## PIC18F87J10 Family Rev. A3 Silicon Errata

The PIC18F87J10 family parts you have received conform functionally to the Device Data Sheet (DS39663D), except for the anomalies described below. Any Data Sheet Clarification issues related to the PIC18F87J10 family will be reported in a separate Data Sheet errata. Please check the Microchip web site for any existing issues.

**The following silicon errata apply only to PIC18F87J10 family devices with these Device/Revision IDs:**

**FIGURE 1: SCKx PULSE VARIATION USING TIMER2/2**

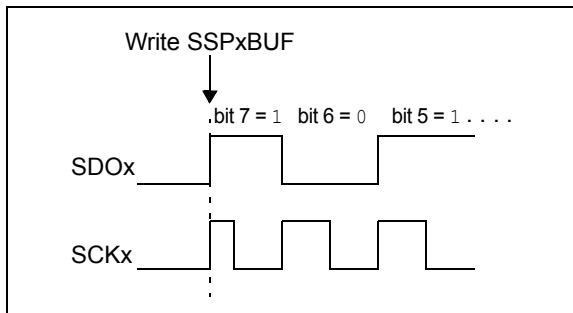
When the SPI is using Timer2/2 as the clock source, a shorter than expected SCKx pulse may occur on the first bit of the transmitted/received data. See Figure 1.

To avoid producing the short pulse:

1. Turn off Timer2.
2. Clear the TMR2 register.
3. Load the SSPxBUF with the data to be transmitted.
4. Turn Timer2 back on.
